CLIO 2

Cancels and replaces Technical Note no. 809A dated July 2001

Modifications: replacement parts.

80B WATER IN THE FRONT FOG LIGHTS

Fig. 1

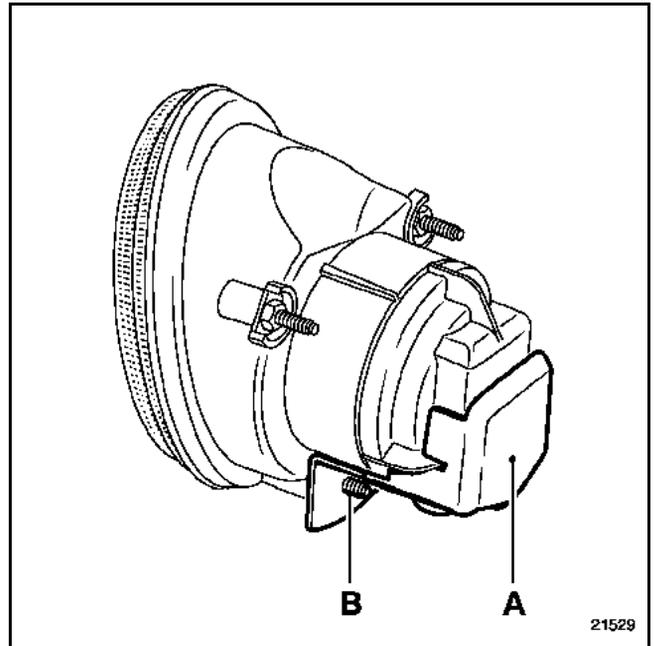
- Replace the fog light wiring.
- Fit two cover masks.

- 1 fog light wiring **Part No.: 82 00 164 962**
- 2 fog light cover masks **Part No.: 82 00 130 905**

- Put the vehicle on a two-post lift.
- Remove the front bumper.
- Replace the fog light wiring.
- Attach the fog light cover masks (A) (**Fig. 1**) using the fog light lower mounting bolt (B) (**Fig. 1**).
- Refit the front bumper.
- Adjust the fog lights.
